NUCLEAR PACKAGING, INC.

REFERENCE: Docket Number 71-9159
NuPac Series A Packaging

Enclosed are revised pages to the Type A Family SAR which have been changed in response to concerns which you discussed with us in recent telephone conversations. Please replace the following SAR pages with the enclosed revised pages.

0 X-20-204D 1 of 2

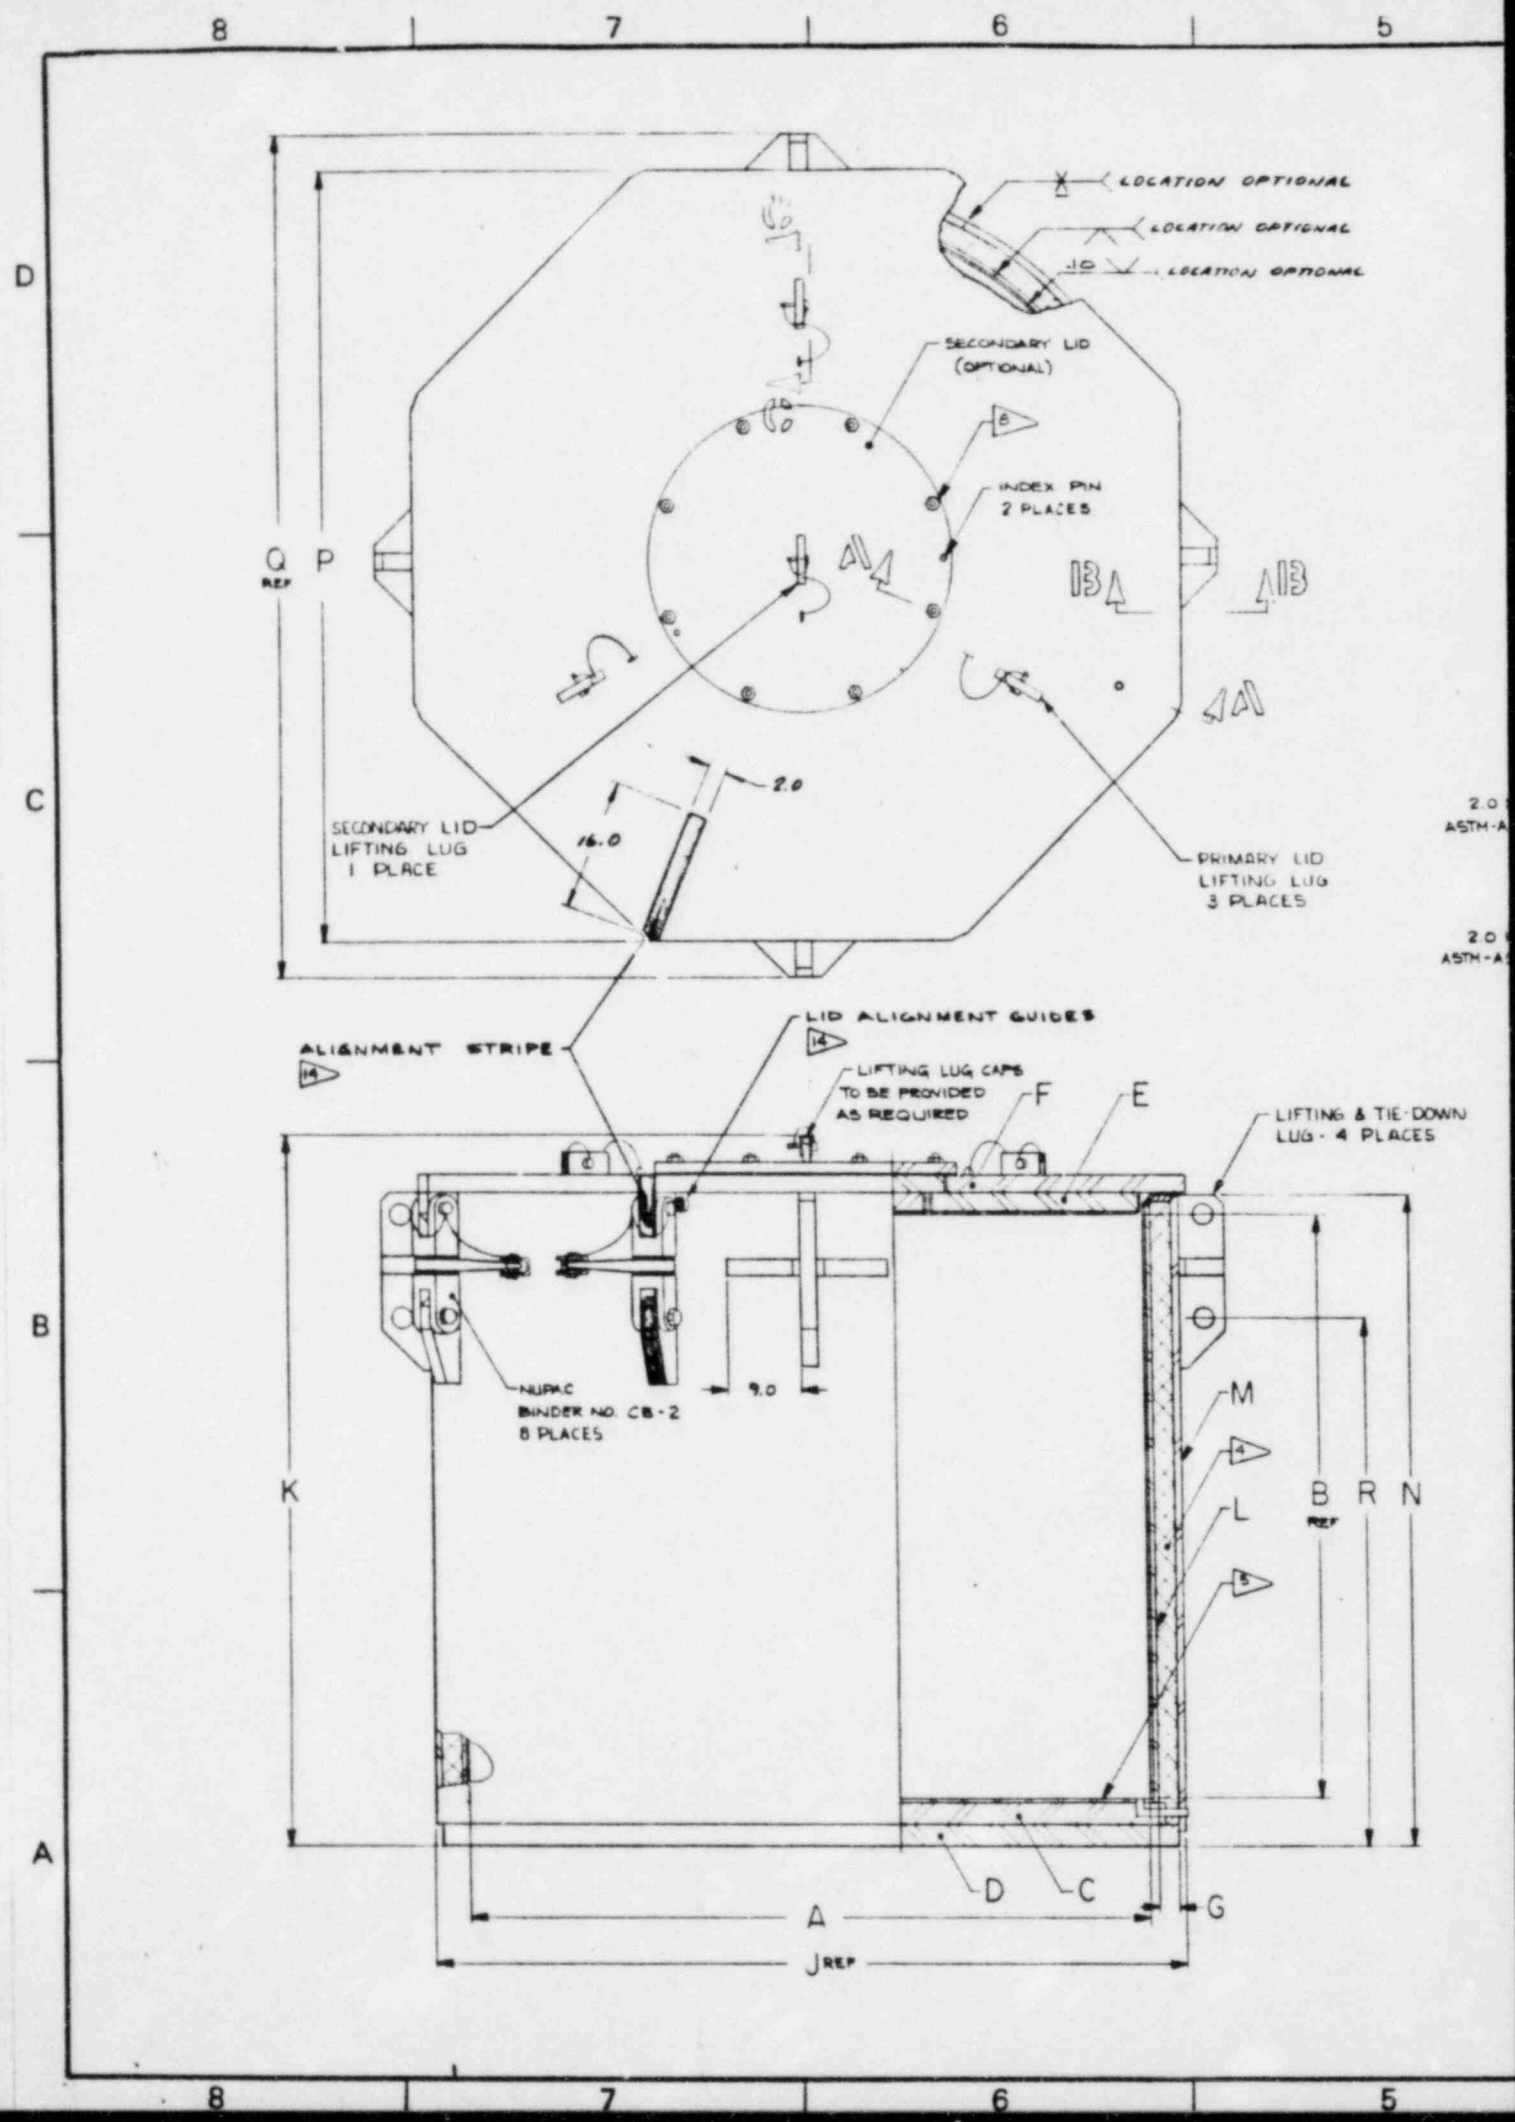
1. Weld callout for the cask inner wall has been changed to accommodate all cask sizes.
2. The Gamma Scan procedure has been modified to include the grid size and additional information on the laboratory calibration procedure.
3. The Ratchet Binder drawing has been given a number (SK-206).
